April 21, 2023

**Re: Allaso Journal Center**  
**7800 Headline Blvd NE**  
**Request for Certificate of Occupancy**  
**Transportation Development Final Inspection**  
Engineer's/Architect's Stamp dated 07-13-20 (D17-D107)  
Certification dated 04-03-23

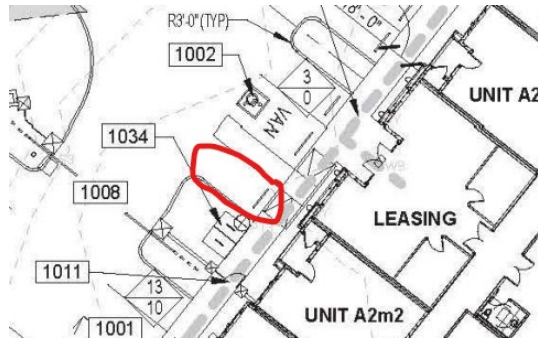
- The provided parking calculations shows 6 ADA parking spaces. The site plan shows only 5 ADA parking spaces. Please clarify.

- Upon site inspection ADA marked parking space (not on plan) is only 8' wide. Minimum ADA parking stall width is 8.5'. See below for location.
